**TOWN OF NEWBURGH
PLANNING BOARD
TECHNICAL REVIEW COMMENTS**

PROJECT NAME: LONGVIEW FARM
PROJECT NO.: 06-39
PROJECT LOCATION: SECTION 20, BLOCK 1, LOT 1
SECTION 20, BLOCK 1, LOT 3.35
REVIEW DATE: 13 JANUARY 2023
MEETING DATE: 19 JANUARY 2023
PROJECT REPRESENTATIVE: T.M. DEPUY ENGINEERING & LAND SURVEYING, PC

LONGVIEW FARM SUBDIVISION SECTION 1, SECTION 2, SECTION 3 AND SECTION 4

SECTION C-C

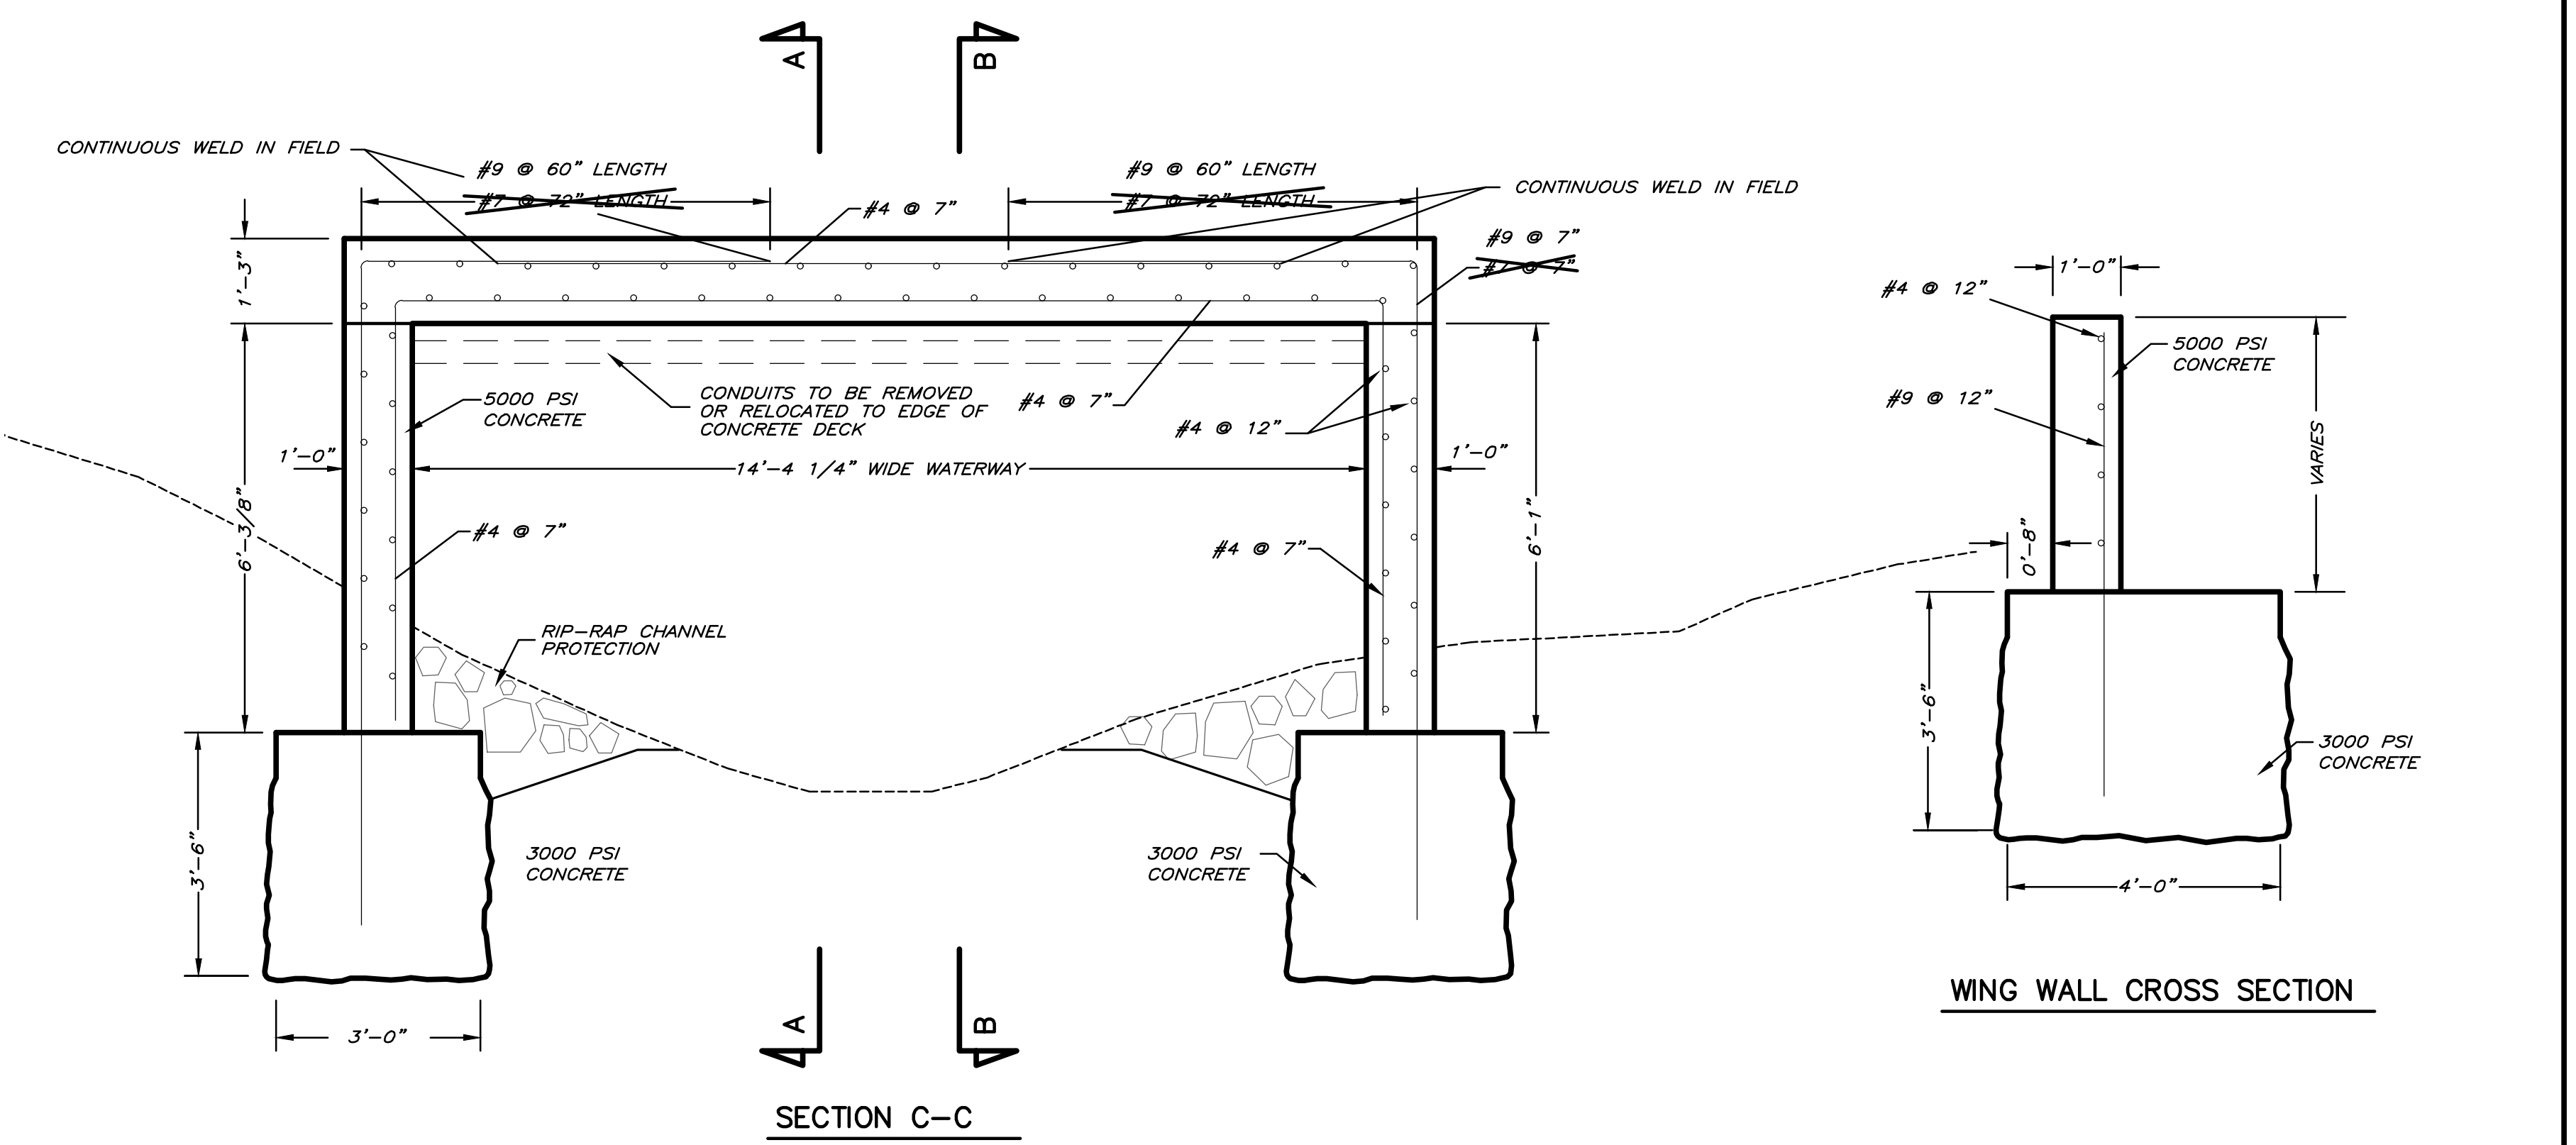
8. The proposed culvert crossing identifies sidewalks on both sides of the culvert in a 28 foot wide driving lane. It is unclear if that exists.
9. Conduits in the culvert are identified to be removed or relocated. The conduits should be removed from interior of the culvert pipe.
